MAINTENANCE INFORMATION Mi06-11

DATE : SEPTEMBER 2006	SECTION : 26 Slide-Out
SUBJECT : REAR SLIDE-OUT GEARBOX LEAKAGE

Execute the following procedure to eliminate leakage on the rear slide-out gearbox.

FIGURE 8

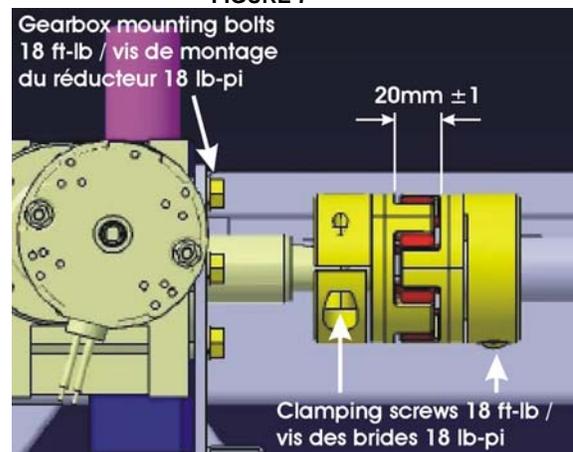
10. Tighten nuts.
11. Reinstall the motor/gearbox assembly using the mounting holes opposite to the gearbox cover. Use 4 mounting bolts. Tighten mounting bolts to a torque of 18 ft-lb in a criss-cross pattern (figure 8).

- b. Reconnect the clamping hubs. If necessary, rotate the motor shaft extension by hand to align the clamping hubs. Leave a gap of 20mm (13/16" approx) between each clamping hubs as shown on figure 8.
 - c. Tighten clamping screws to a torque of 18 lb-ft (figure 8).

FIGURE 9

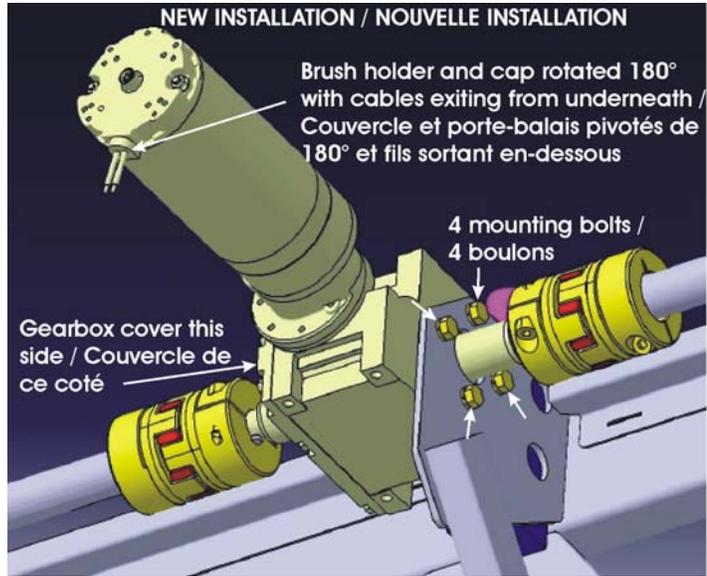
13. Connect the motor electrical cable connector. See new installation on figure 9.

FIGURE 10

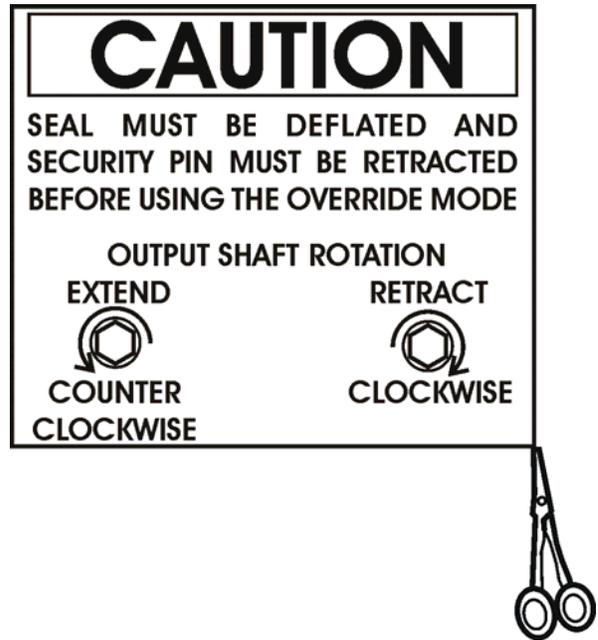
14. Place decal #478251 or figure 10 over the existing decal.
